SUBJECT: REVIEW OF PRELIMINARY ACCIDENT SEQUENCE PRECURSOR  
ANALYSIS OF EVENT AT ST. LUCIE PLANT, UNIT 1

## LER Nos. 335/95-004, -005, -006

Plant: St. Lucie 1

Licensee Comments

Fig. 2 Dominant core damage sequence given a LOOP for LER Nos. 335/95-004,-005,-006.

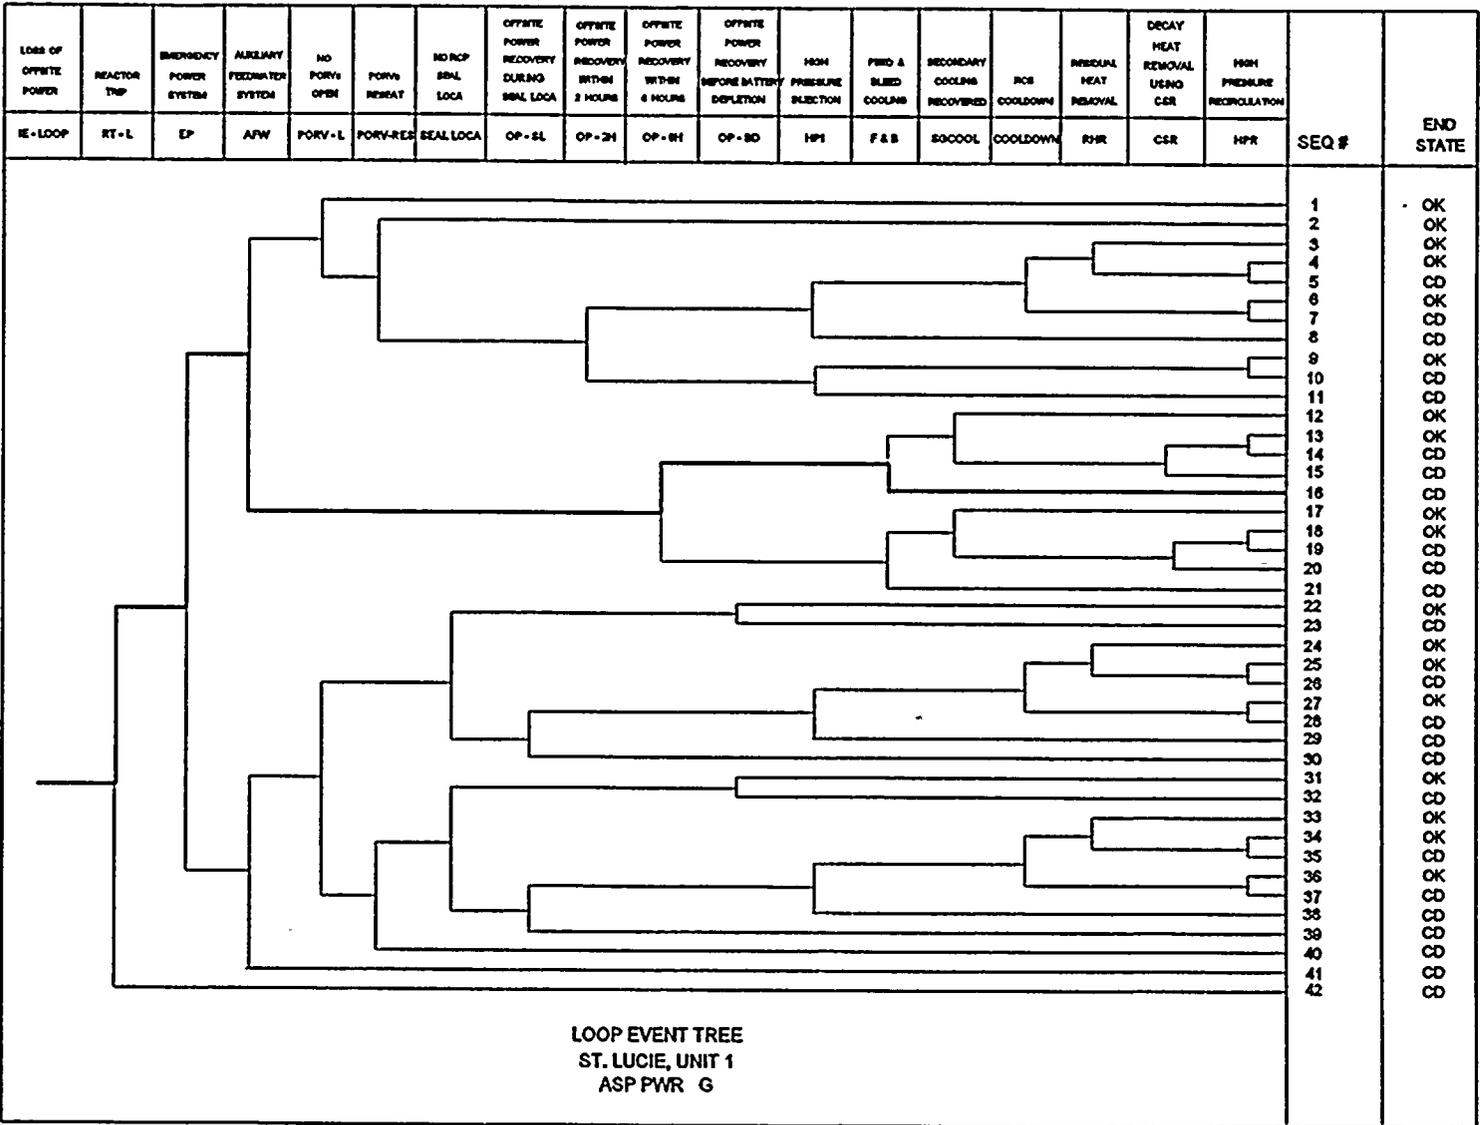
**Comment 3a:** (Summary) LOOP sequences 16 and 21 are essentially the same except for whether offsite power is recovered within 6 h. The representation of these sequences in the event tree is confusing. It appears that the sequence for feed and bleed failure is not correct in that it occurs after the attempted recovery of offsite power at 6 h is either successful or fails. Feed and bleed is a short term action (less than 30 min) after a complete loss of feedwater.... It is recommended that since LOOP 16 is a dominant contributor to the total CCDP, that the actual sequence of events represented by sequences LOOP 16 and LOOP 21 be more clearly explained, and that the potential for recovery of MFW and/or condensate pumps be evaluated.

**Response 3a:** The representation of offsite power recovery in the LOOP event tree is not necessarily chronological. In the blackout sequences, the probability of an RCP seal LOCA and the probability of failing to recover AC power are calculated using a convolution approach that recognizes that both probabilities are a function of time. The model recognizes that offsite power will likely be recovered after feed and bleed is demanded, and requires EDG success for feed and bleed success. The intent of the 6 h recovery of offsite power branch is to address the potential for recovery of an initially failed AFW system before transfer to sump recirculation. Since feed and bleed has been demanded and has failed in this sequence before this time because of the unavailable PORVs, the potential recovery of offsite power by 6 h has no effect on the overall analysis results (LOOP 16 and LOOP 21 together represent the dominant sequence for the event). The description of the LOOP 16 sequence in Analysis Results has been clarified to address this by adding the following footnote

<sup>6</sup> The LOOP event tree includes the successful recovery of offsite power within 6 h in the dominant sequence. This is an artifice of the top event ordering. Feed and bleed challenge would occur about 20 min after the trip, and core damage would begin shortly thereafter. Sequences 16 and 21 together represent the core damage sequence involving emergency power success and AFW and feed and bleed failure.
